REVISED
07.08.2015

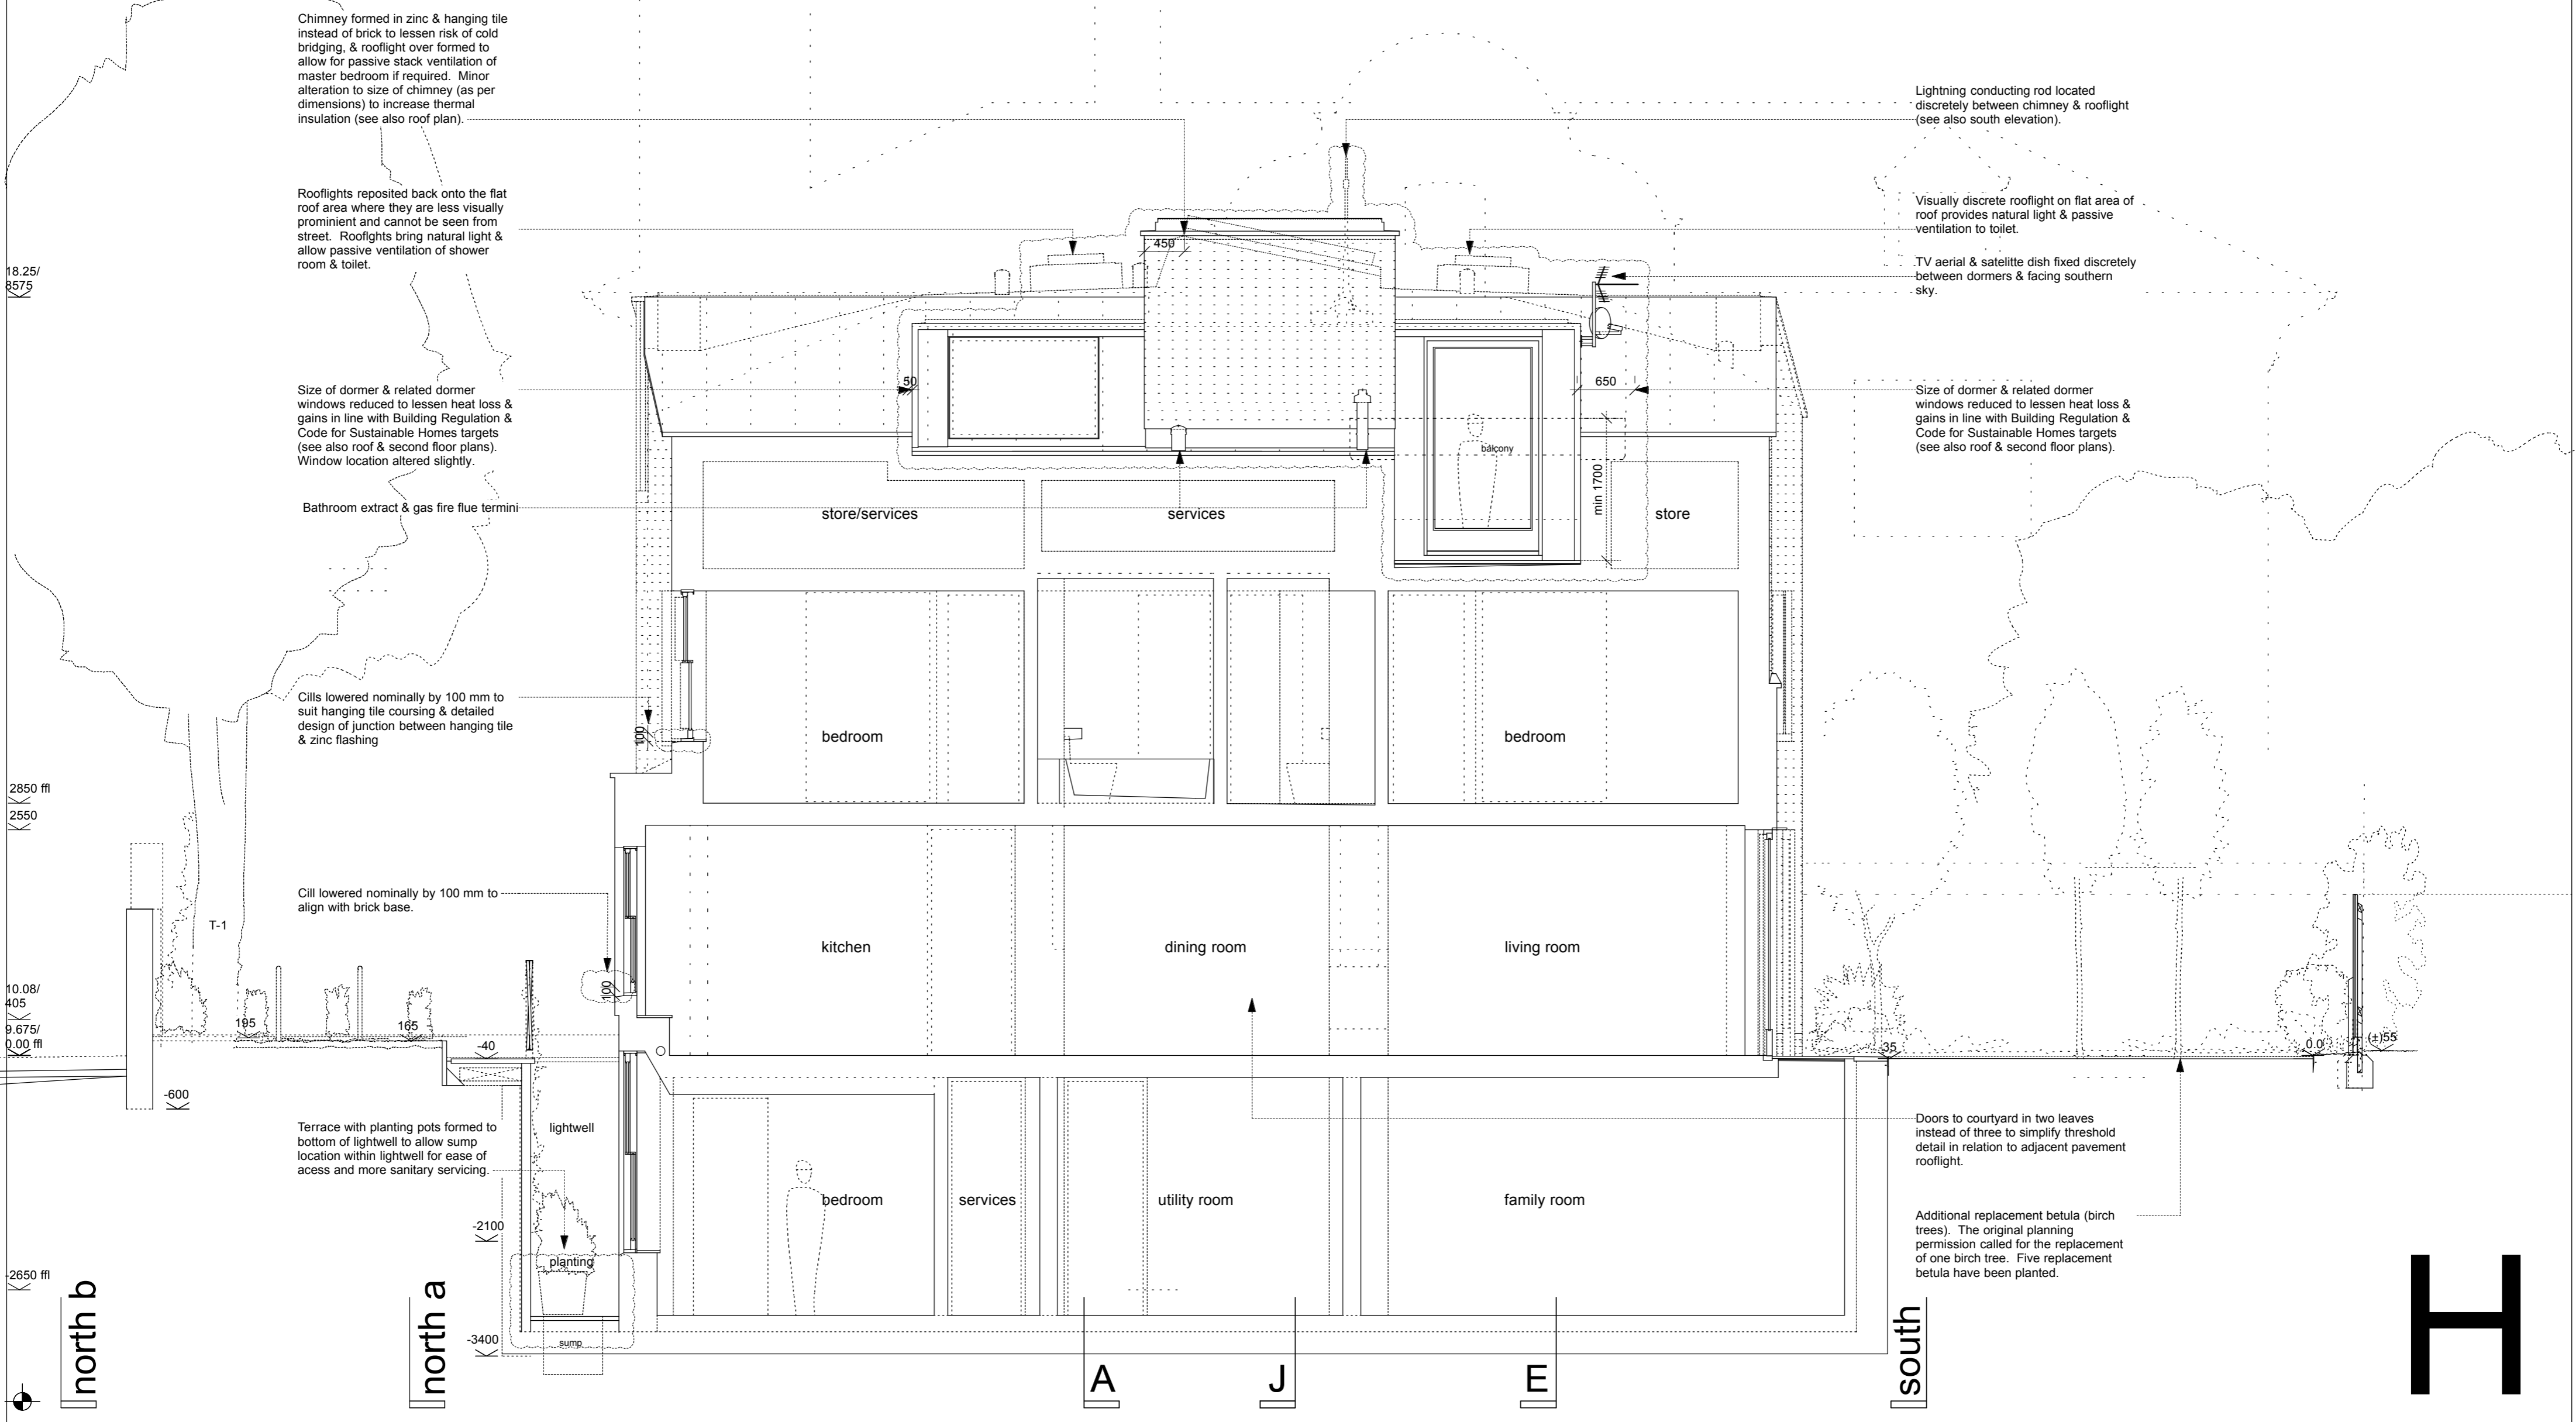
Chimney formed in zinc & hanging tile instead of brick to lessen risk of cold bridging, & rooflight over formed to allow for passive stack ventilation of master bedroom if required. Minor alteration to size of chimney (as per dimensions) to increase thermal insulation (see also roof plan).

Rooflights repositioned back onto the flat roof area where they are less visually prominent and cannot be seen from street. Rooflights bring natural light & allow passive ventilation of shower room & toilet.

Size of dormer & related dormer windows reduced to lessen heat loss & gains in line with Building Regulation & Code for Sustainable Homes targets (see also roof & second floor plans). Window location altered slightly.

Bathroom extract & gas fire flue termini

Cills lowered nominally by 100 mm to suit hanging tile coursing & detailed design of junction between hanging tile & zinc flashing

Cill lowered nominally by 100 mm to align with brick base.

Terrace with planting pots formed to bottom of lightwell to allow sump location within lightwell for ease of access and more sanitary servicing.

Lightning conducting rod located discretely between chimney & rooflight (see also south elevation).

Visually discrete rooflight on flat area of roof provides natural light & passive ventilation to toilet.

TV aerial & satellite dish fixed discretely between dormers & facing southern sky.

Size of dormer & related dormer windows reduced to lessen heat loss & gains in line with Building Regulation & Code for Sustainable Homes targets (see also roof & second floor plans).

Doors to courtyard in two leaves instead of three to simplify threshold detail in relation to adjacent pavement rooflight.

Additional replacement betula (birch trees). The original planning permission called for the replacement of one birch tree. Five replacement betula have been planted.
